ADDENDUM No. 1

ITB No. 4367

Lawrence Street Water Main Replacement and Summit Street Water Main Replacement Project

⁴ OF 11

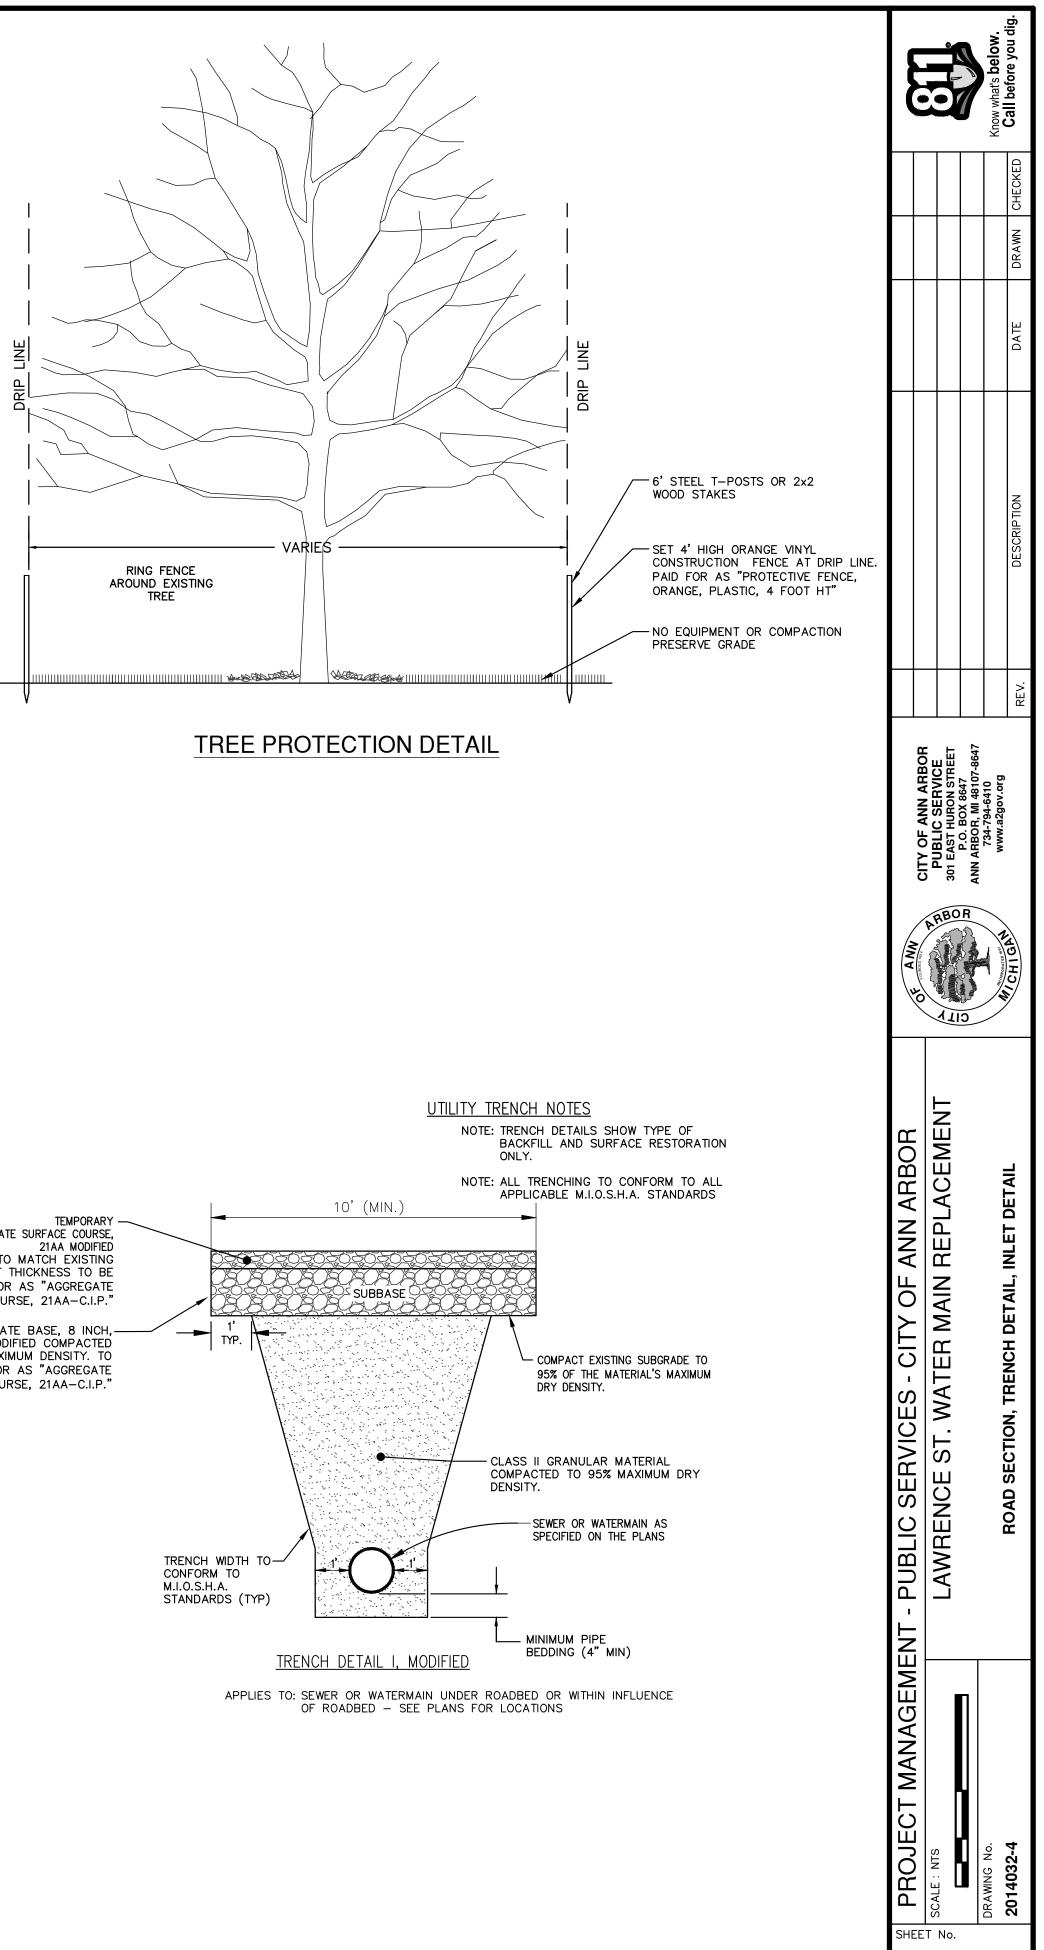
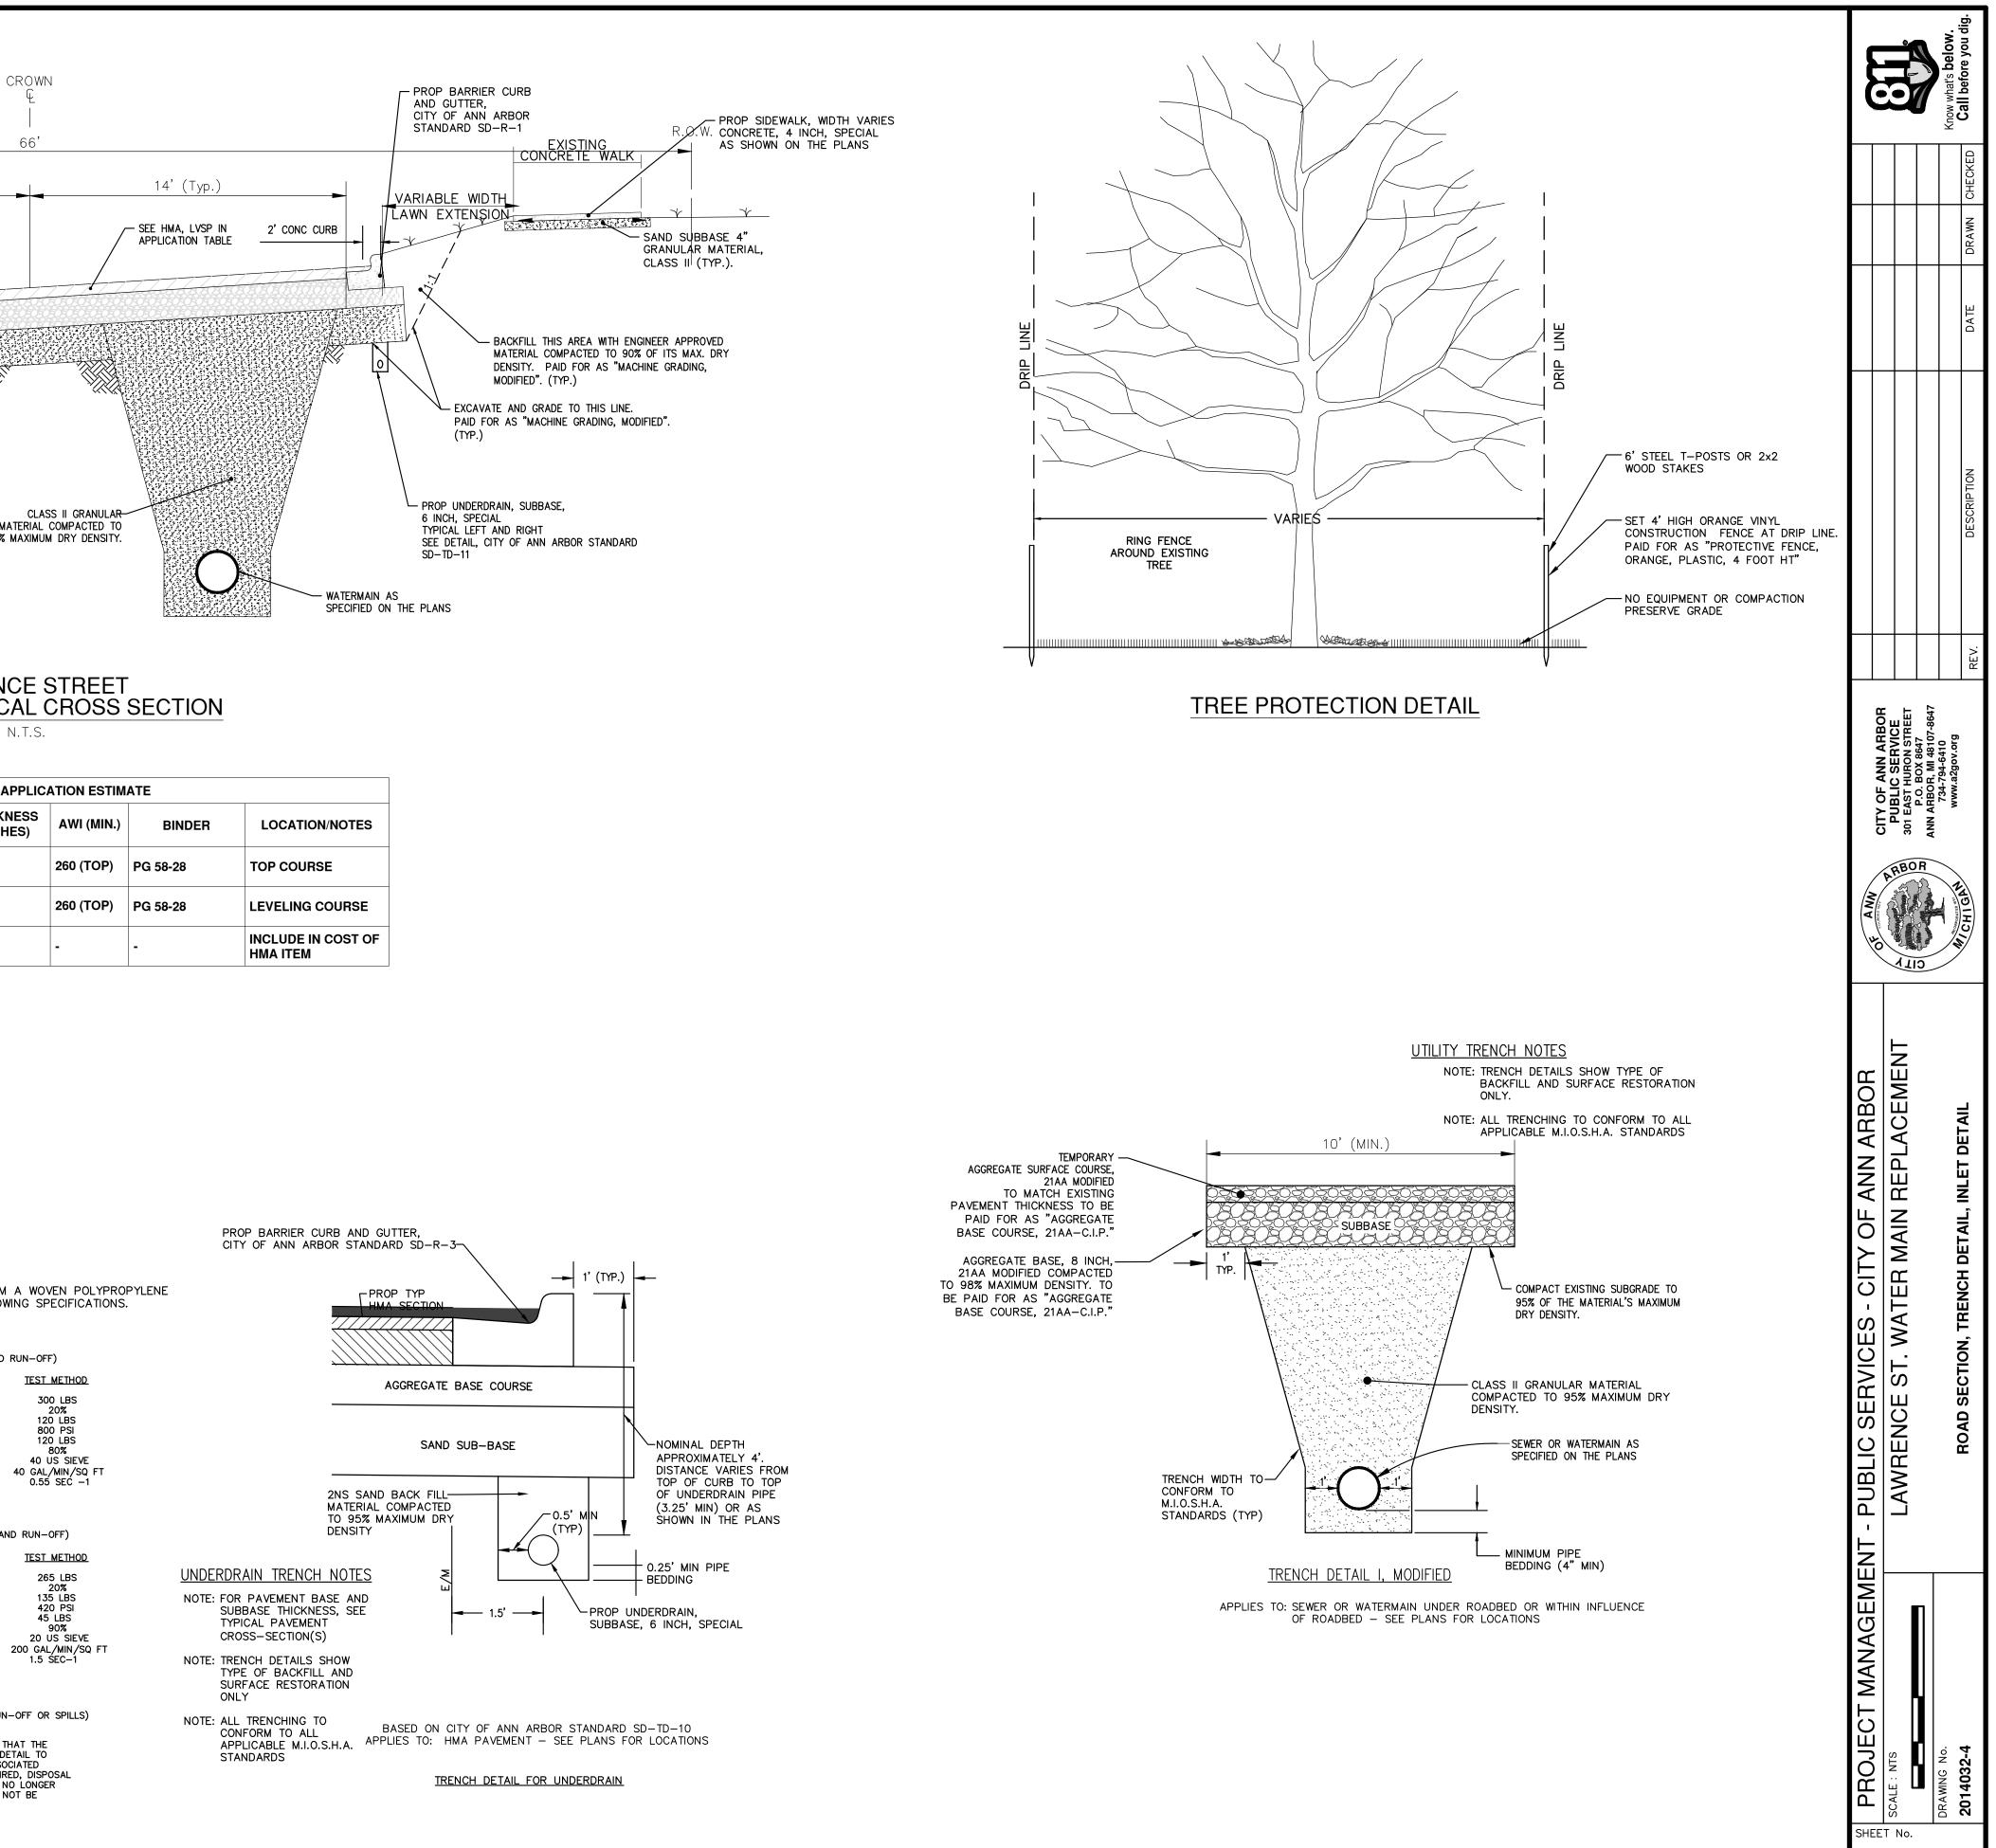
Item # 6: Contract Plan Set Replace plan sheets 4 and 9 with attached plan sheers. The revised plans show changes to the Trench Detail and water main connection notes.
